**TOWN OF NEWBURGH  
PLANNING BOARD  
REVIEW COMMENTS**

**PROJECT: DEPEW ENERGY COMPANY AMENDED SITE PLAN**  
**PROJECT NO.: 14-09**  
**PROJECT LOCATION: SECTION 43, BLOCK 5, LOTS 41.2 & 42**  
**PROJECT REPRESENTATIVE: ENGINEERING & SURVEYING PROPERTIES**  
**REVIEW DATE: 29 AUGUST 2014**  
**MEETING DATE: 4 SEPTEMBER 2014**

**RE: DEPEW ENERGY CO.  
RTE 9W SITE PLAN AMENDMENT  
TAX LOT # 43-5-41.2 & 42**

**SITE PLAN**

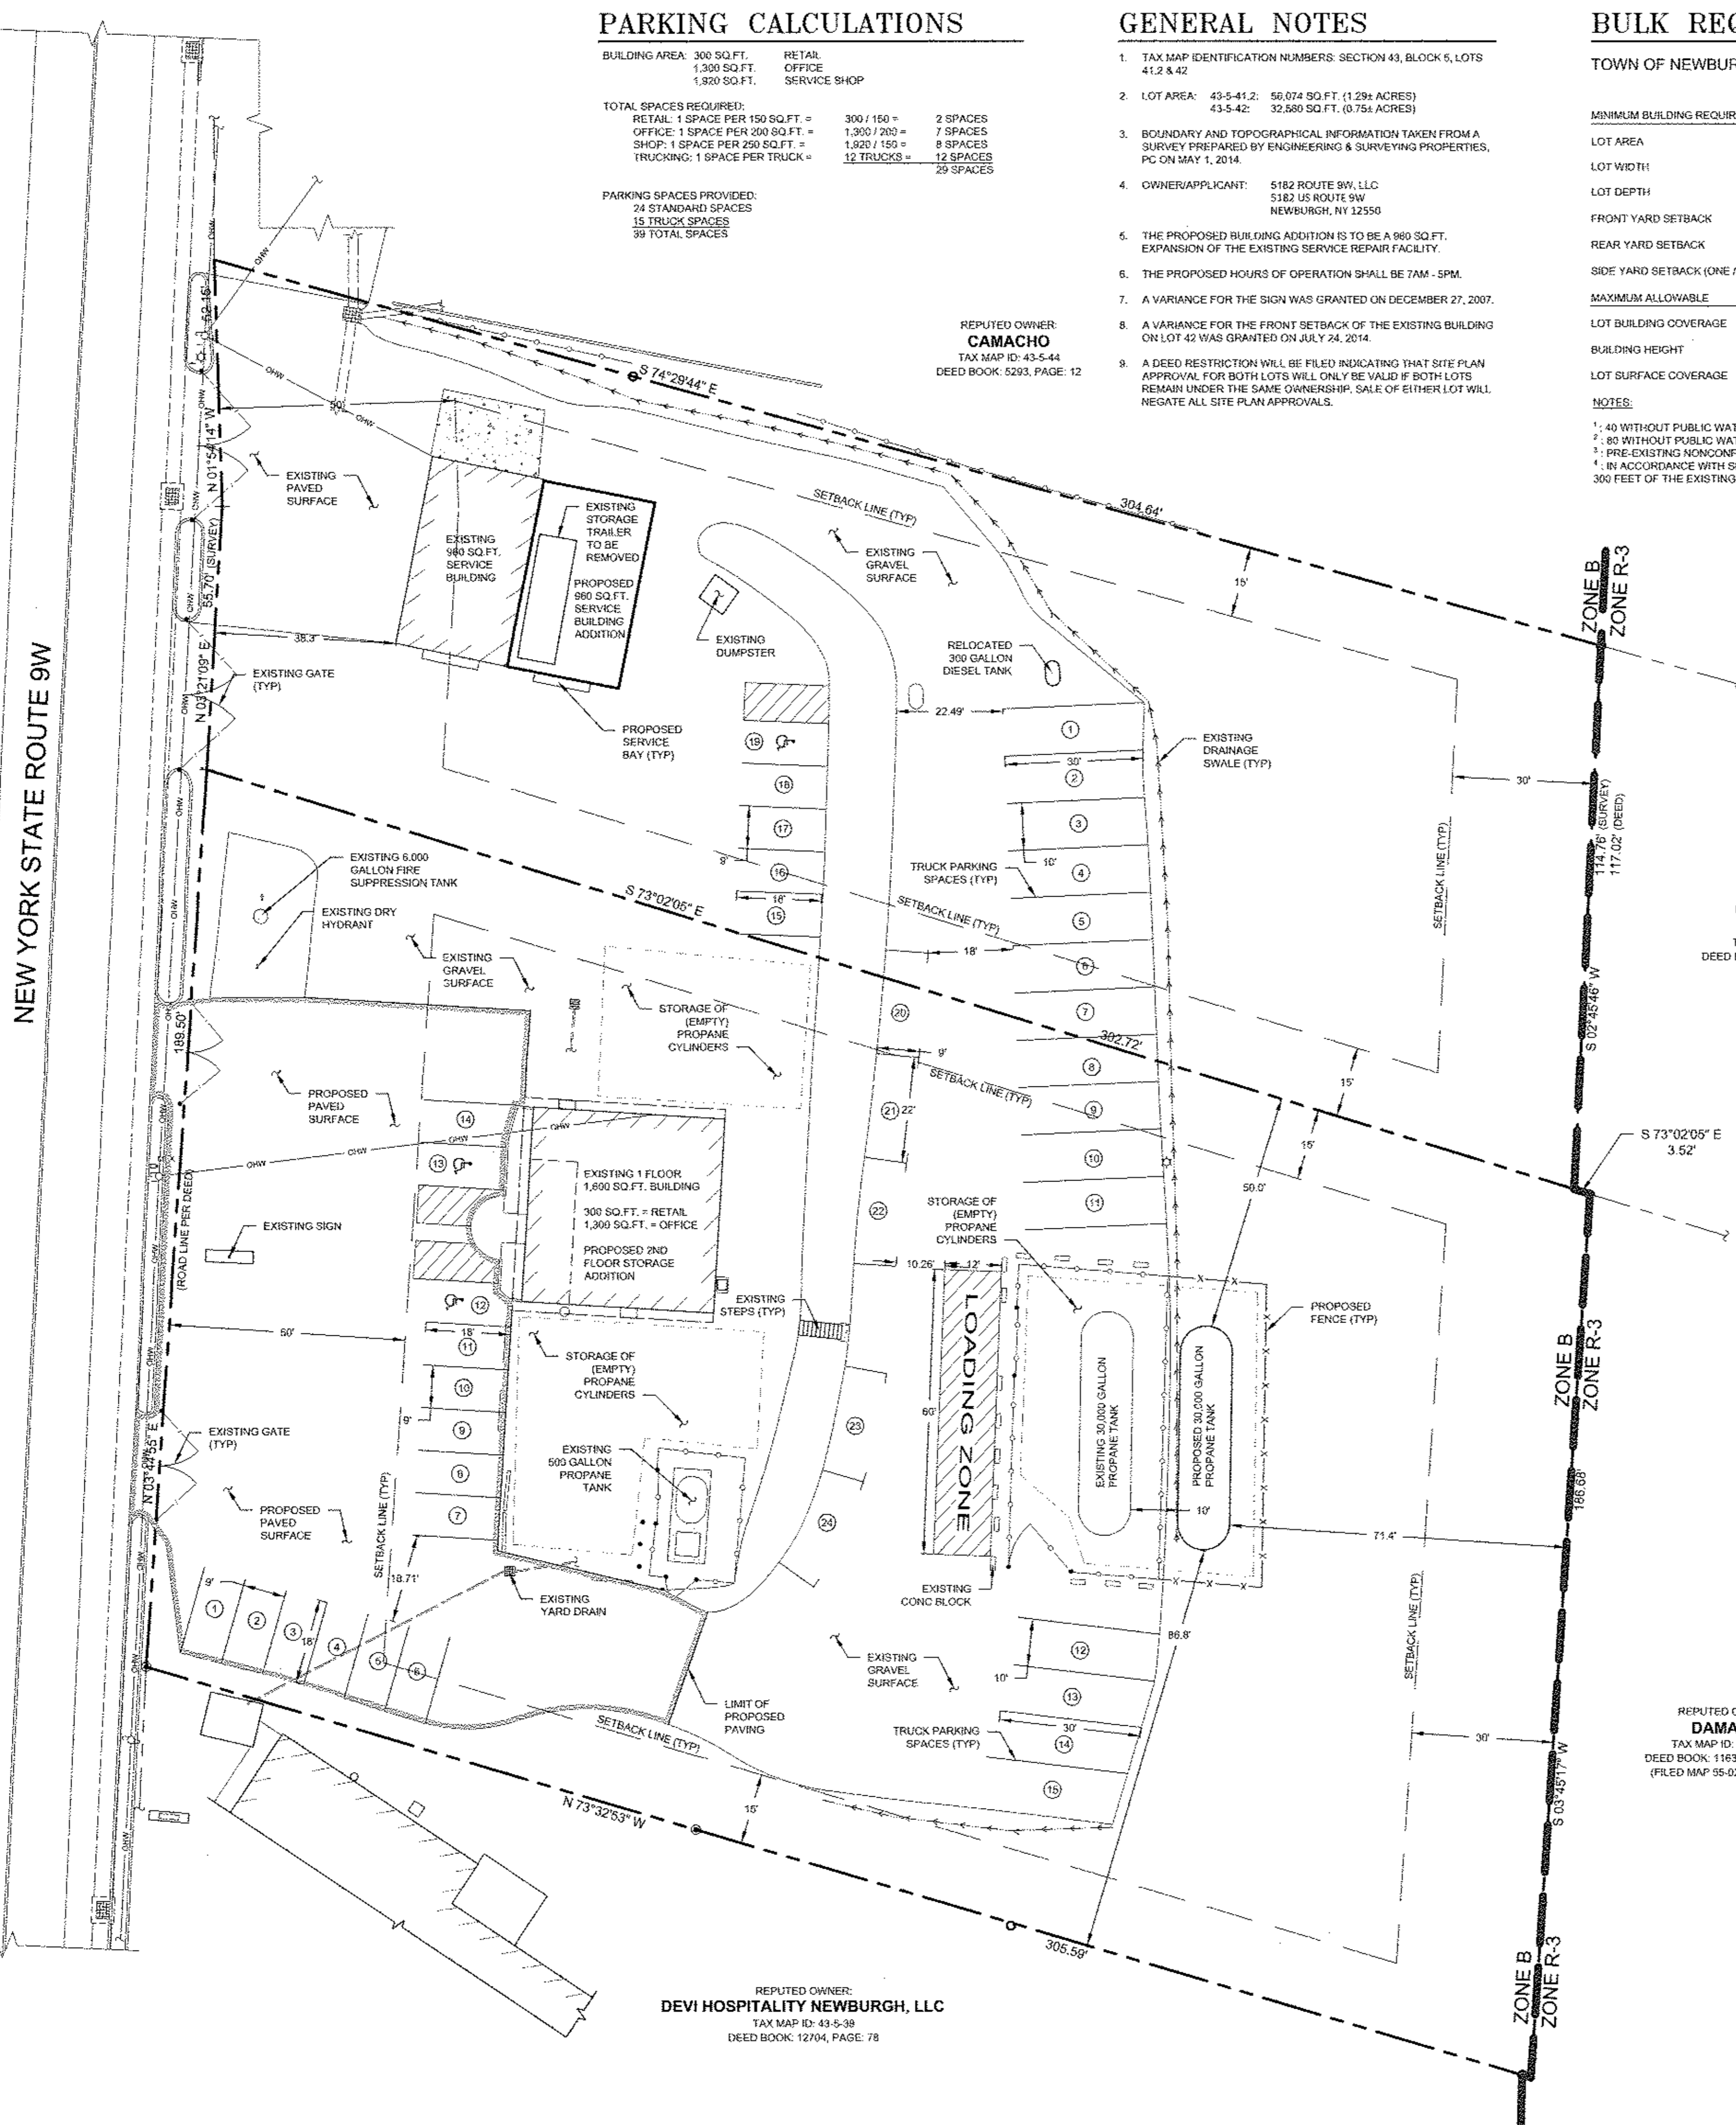
5. Handicap parking spaces do not appear to comply with details depicted on detail sheet and ADA requirements. Striping for the handicap parking must be in compliance with detail provided.

8. Jerry Canfield's comments regarding the 18.7 foot wide drive lane created by parking space 5 & 7 should be received.

**GRADING, DRAINAGE & UTILITY PLAN**

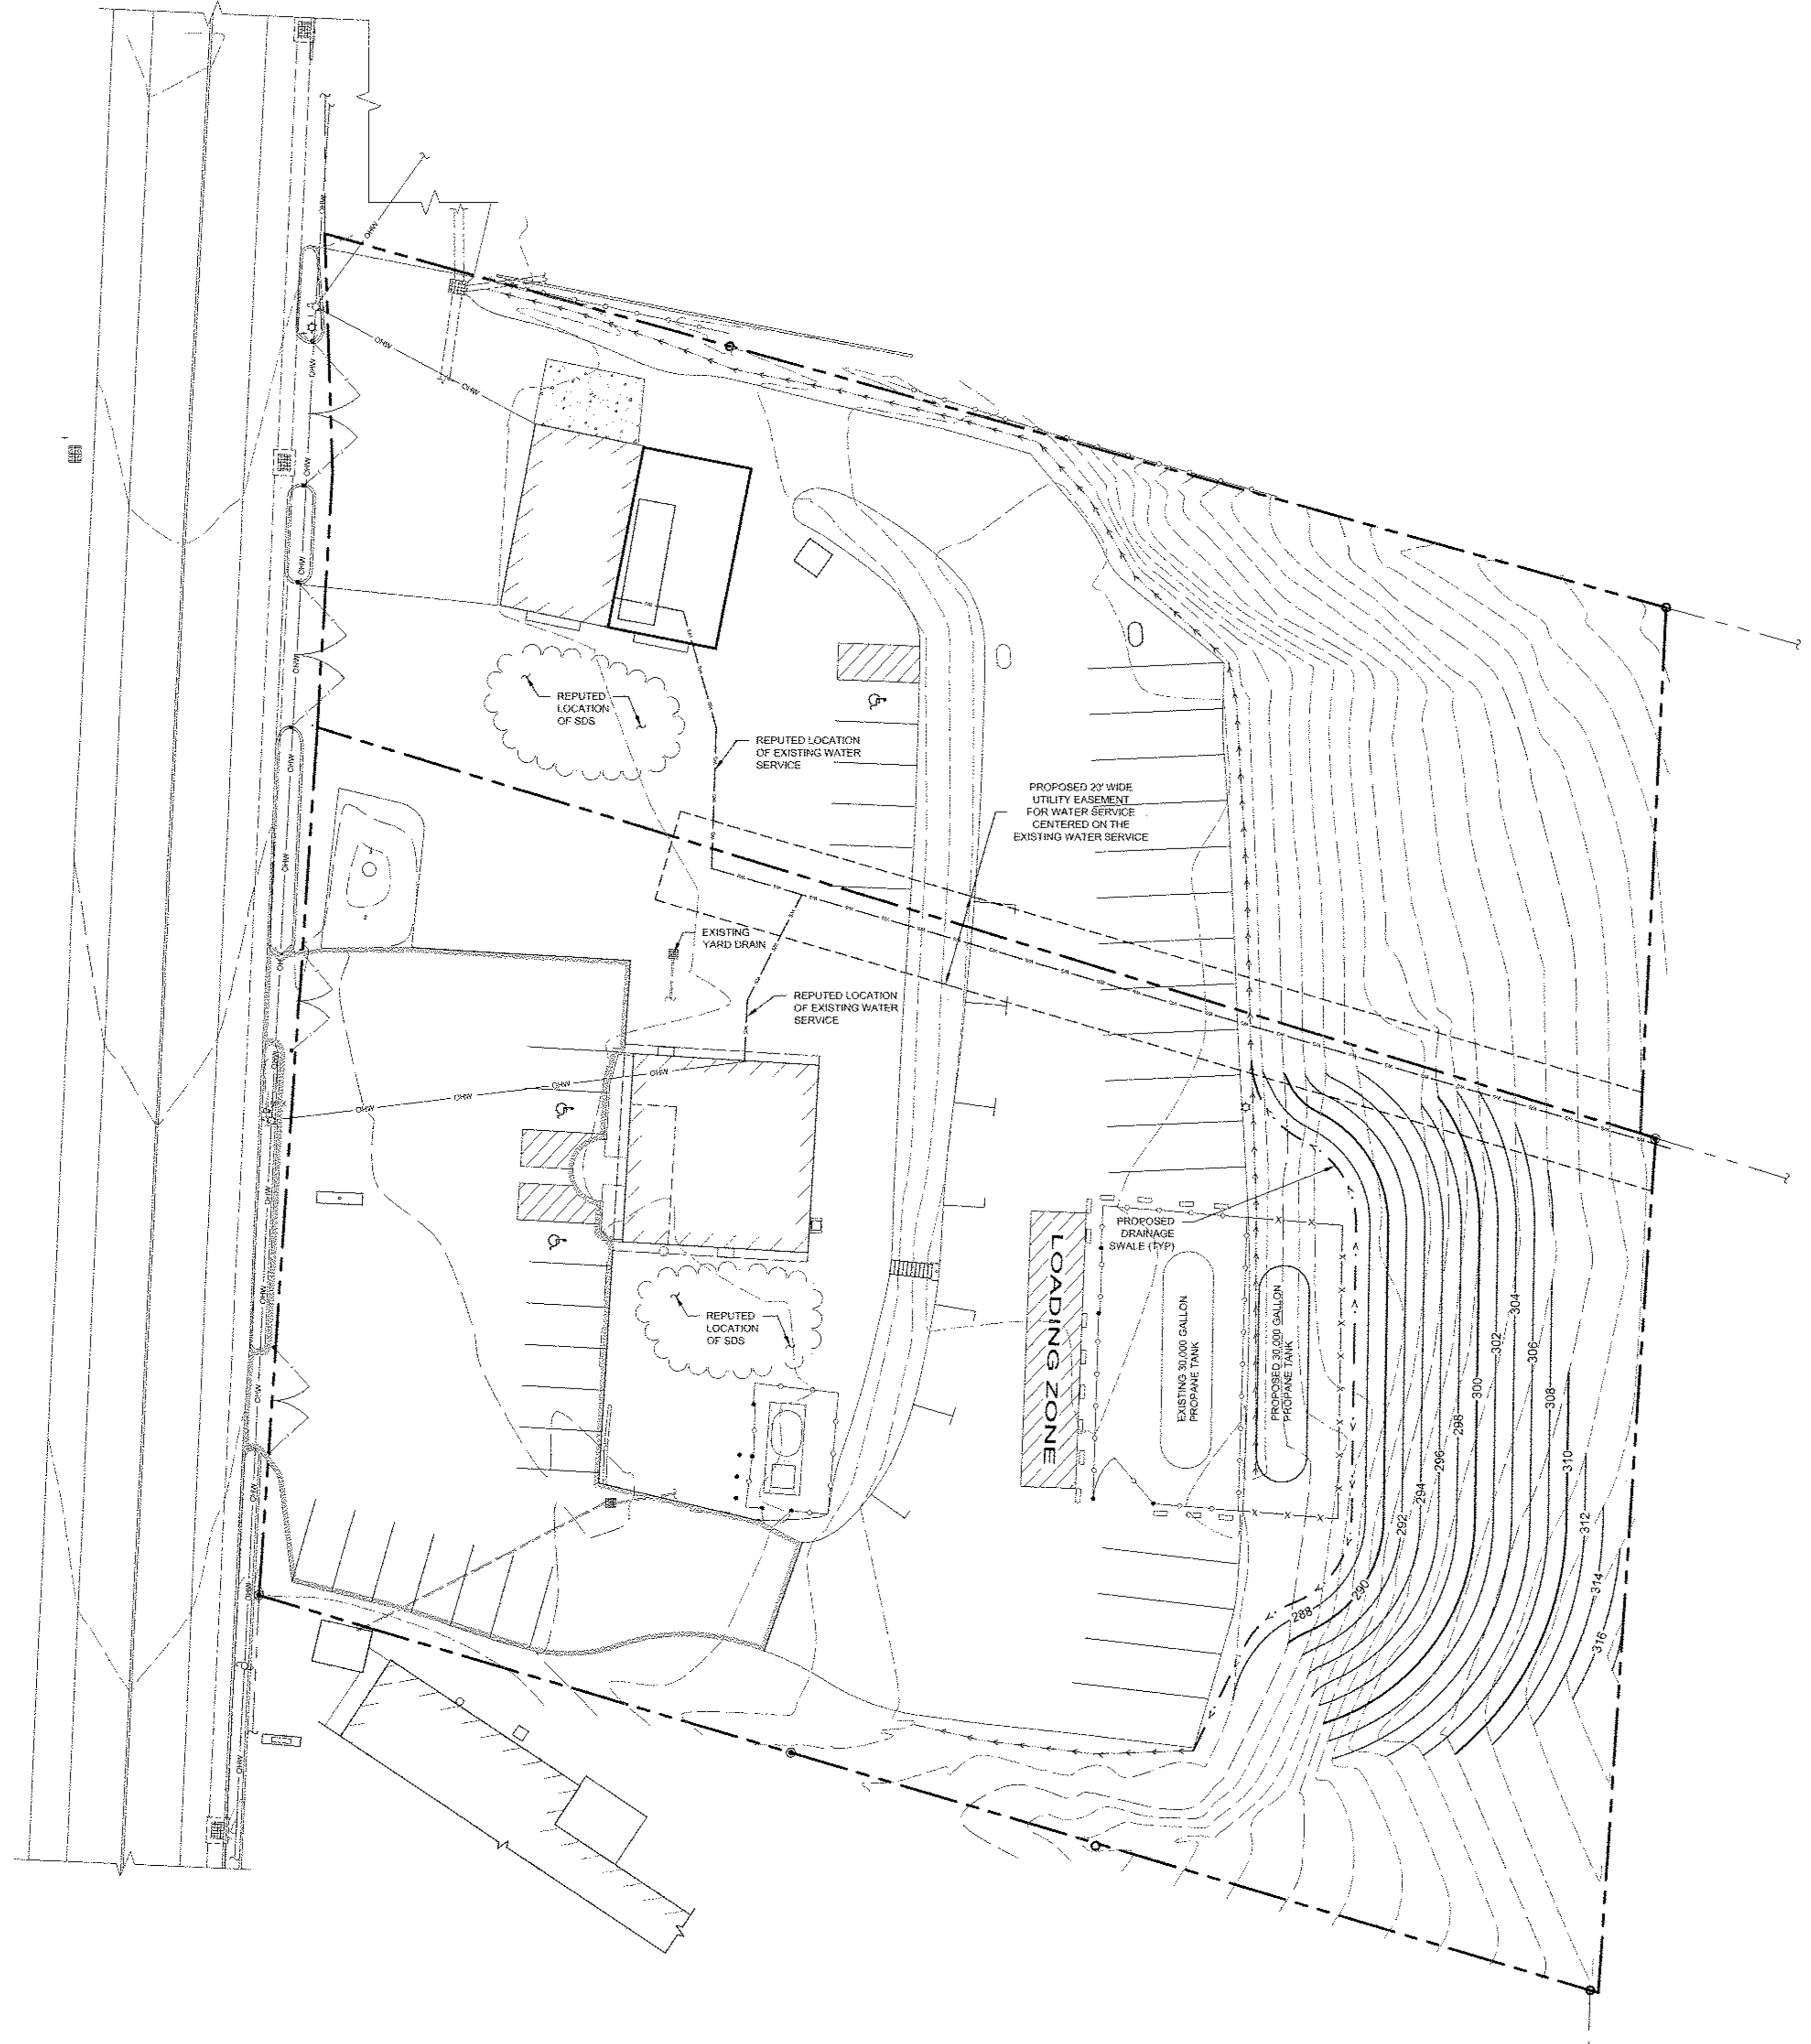
9. Compliance with Section 185.30A(3) requiring outdoor storage be appropriately screened with landscaping so as to provide an opaque sight barrier at least 8 feet in height. In no case shall materials be stored as to exceed the height of the sight barrier.
10. A grading plan has identified significant regrading of the rear slope. We would recommend additional details be provided including seed specification, topsoil requirements, etc.

- 3) A variance for the existing sign was granted on December 27, 2007.
- 4) A grading plan has been added to the plan set.
- 5) The limits of proposed paving are shown on the plan; a thick shaded line has been added to the limits of paving to clearly define the limits.
